SERVICE BULLETIN #43

SUBJECT: Wing Lock Back Brace

APPLICABILITY: All Series 5 Taildraggers

Figure 1 - Wing Lock Back Brace Inspection

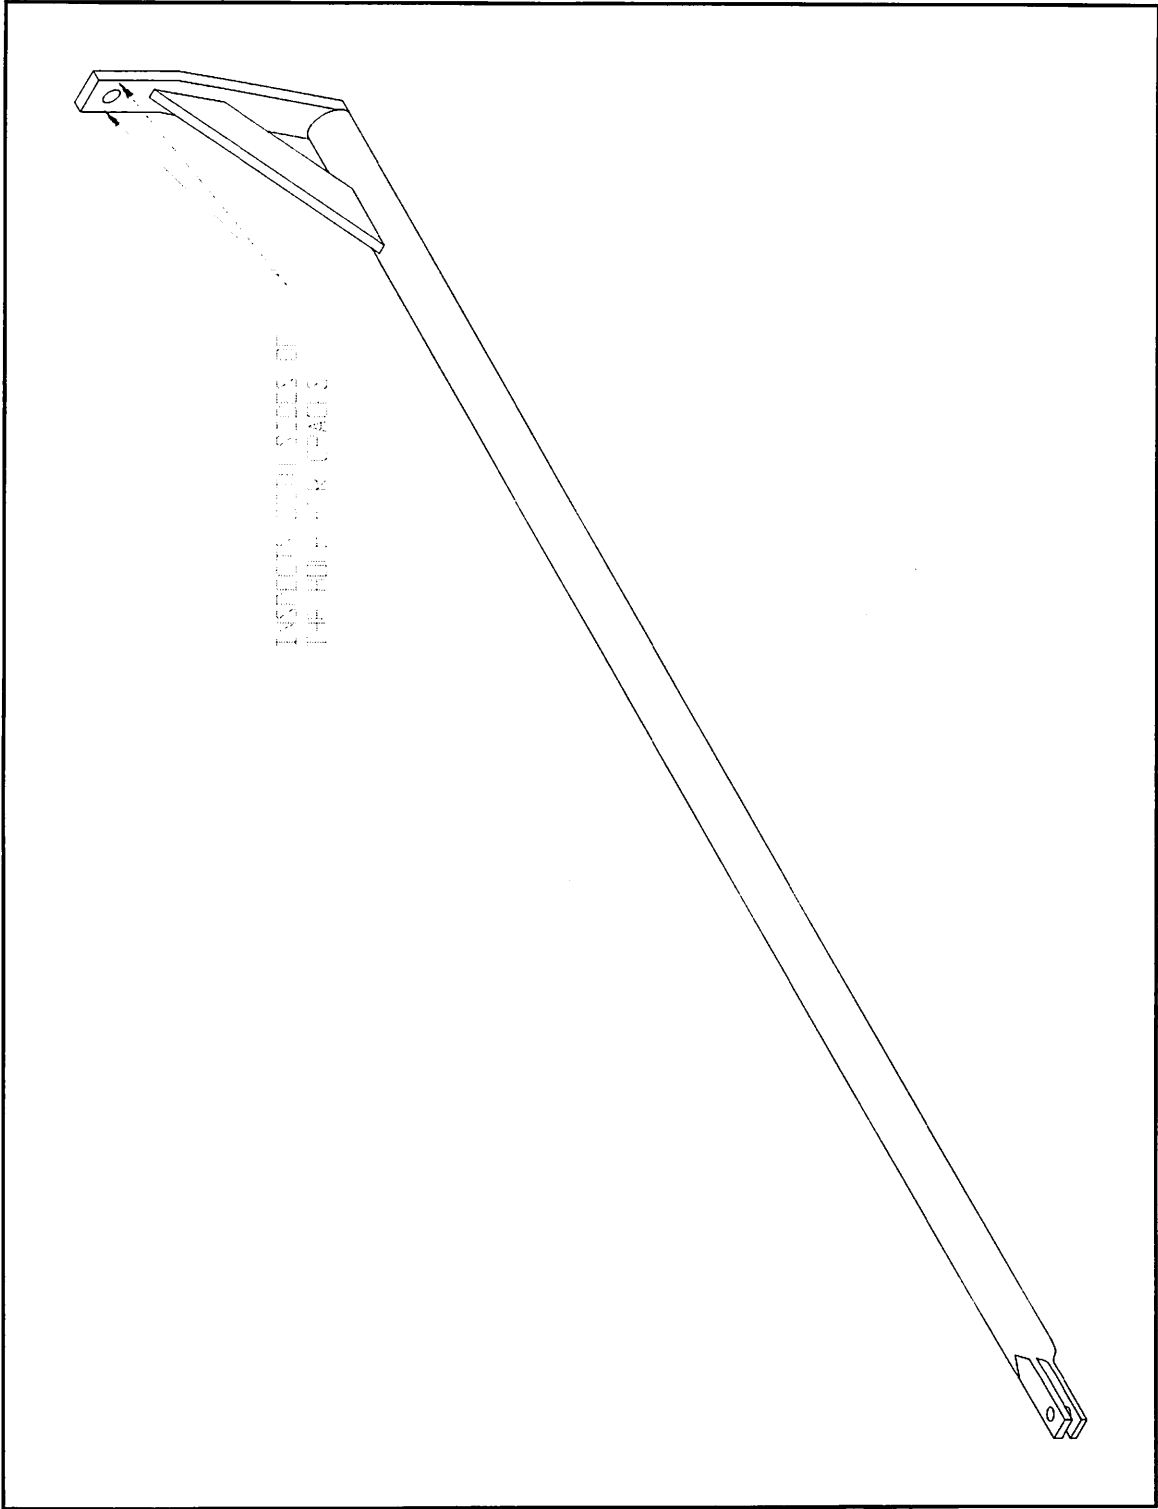
It has been brought to our attention that the wing lock back braces for Series 5 aircraft may be susceptible to cracking on the sides of the hole in the bracket with repeated use. Because of this, we ask that you inspect the area surrounding the hole for cracking prior to each use. If there is any sign of cracks developing around the hole, do not use the braces to tow the aircraft. Call SkyStar's Customer Service Department at 208-466-1711 if you find cracks or have any questions.
